MFN 12-086, Revision 2

GEH Final Response to RAI 3.9-277

NRC RAI 3.9-277

Figure 1 - Typical Weld Joints

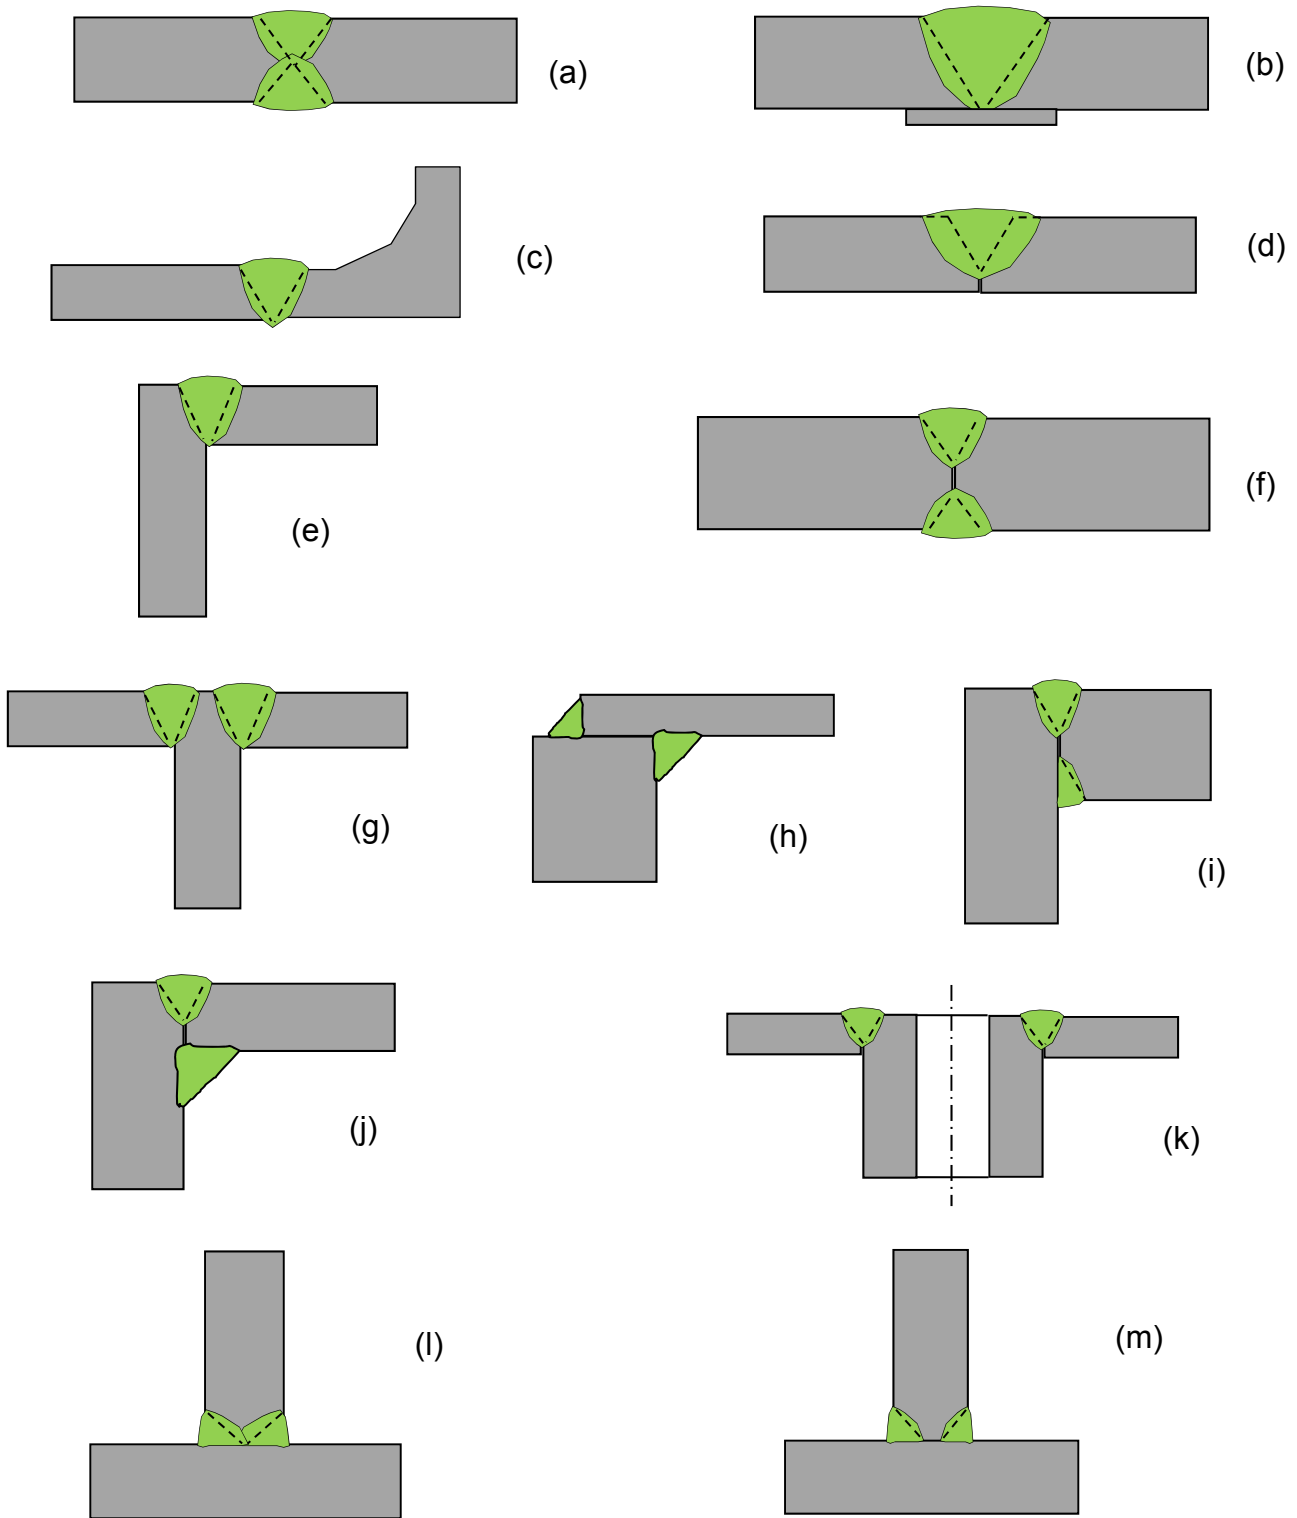
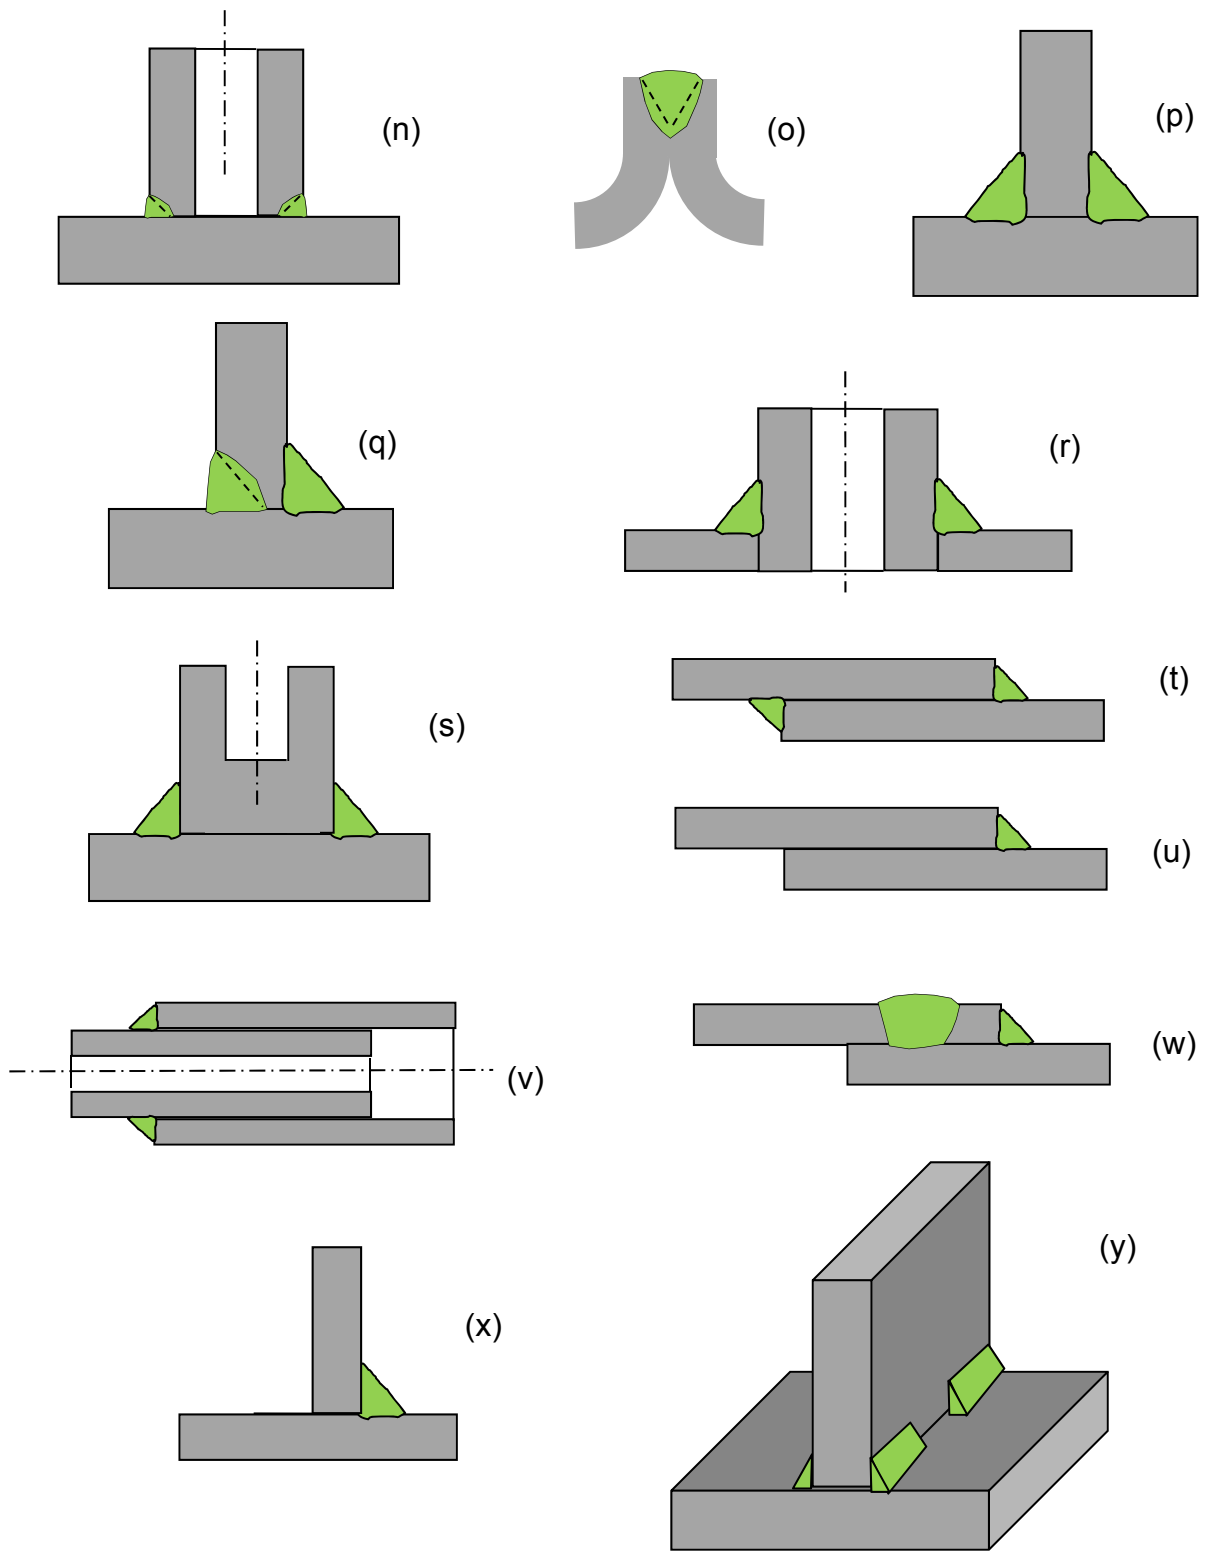
The staff's question is in regard to the use of specific types of welds in the ESBWR steam dryer and the justification for fatigue and quality factors for each weld type.

GEH is requested to discuss the use of specific types of welds in the ESBWR steam dryer and the justification for fatigue and quality factors for each weld type. In addition, GEH is requested to discuss the [[]] in the ESBWR steam dryer as described in NEDE 33313P, Rev 2. During the audit, the staff asked GEH to address the [[]] in the ESBWR steam dryer design, and how the [[]] will be conducted. At the audit, GEH made a definitive statement that the ESBWR steam dryer design [[]]. The staff noted that this is inconsistent with NEDE 33313P, Rev 2. Please provide clarification if [[]] in the ESBWR steam dryer.

The specific types of welds (ref. 1) used in ESBWR steam dryer design are groove welds and fillet welds. Note the other two basic types of welds; plug or slot welds, and intermittent welds; are not used in ESBWR steam dryer design. This does not include the vane assemblies used for moisture removal which may contain [[
]]. The types of joints (ref. 1) used in design may include butt joint, corner joint, T joint, and lap joint; although an edge joint will not be considered as explained later in this section.

- a.) Butt joints, NG-3352 Type I. Butt joints are full penetration groove welds, Figures 1(a) and 1(c). [[
]].
- b.) Corner joints, NG-3352 Type III and some Type V. Corner joints are constructed using groove welds or fillet welds. As indicated in DCD 26A6642AN section 3L.2.3 (ref. 7), joints are designed [[
]].

c.) T-joint, NG-3352 Type III, some Type V and some Type VII. T-joints are constructed using groove welds or fillet welds.

- Type III T-joints will use full penetration groove welds, Figure 1(l), [[

d.) Lap joint, NG-3352 Type V. All lap joints will be [[

e.) Edge joint, NG-3352 Type VI. This joint design, Figure 1(o) is not used since the edge joint [[

f.) Plug or slot welds and intermittent welds, NG Type VIII will not be used in ESBWR steam dryer design. Figure 1(w) shows a lap joint with a fillet weld and plug weld similar to that used in some thin wall vessels. Plug and slot welds [[

Figure 6.5: Groove weld geometry and nomenclature (ref. 1).

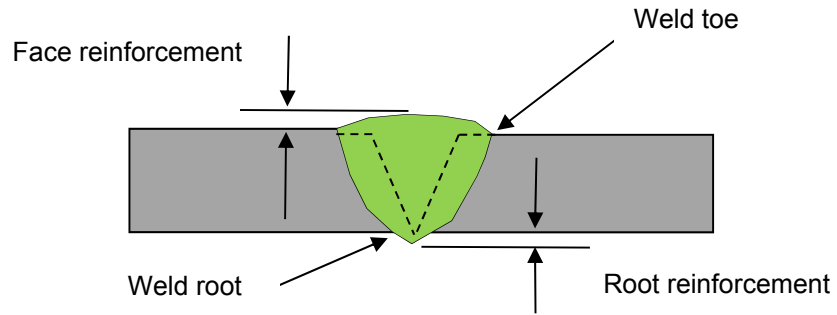
3.) *The draft RAI response states in section 3.1.1 "Full penetration groove welded butt joints, corner joints and T-joints: NG-3352 Types I and III:*

If GEH is consistently following NG 4424 and NG 4426, it appears to be unnecessary to apply a 1.4 weld fatigue factor to "secondary" full penetration welds, in recognition of "the local discontinuity present at the toe of the groove weld due to weld reinforcement." As noted in the response, NG specifies 1.0. Please provide an explanation for this apparent inconsistency. Also, confirm or correct staff's understanding that GEH has committed to NG including NG 4424 and NG 4426, with the only exception being the weld fatigue factors and the weld quality factor applied to "non-structural" welds.

In DCD 26A6642AK (ref. 15) section 3.9.5, GEH committed to the design of reactor internals structures classified as non-safety related as complying with the requirements for ASME BPV Code Article NG-3000 except for the weld quality and fatigue factors for secondary structural welds. Therefore, [[

Shell Model's Groove Weld Fatigue Factor Discussion
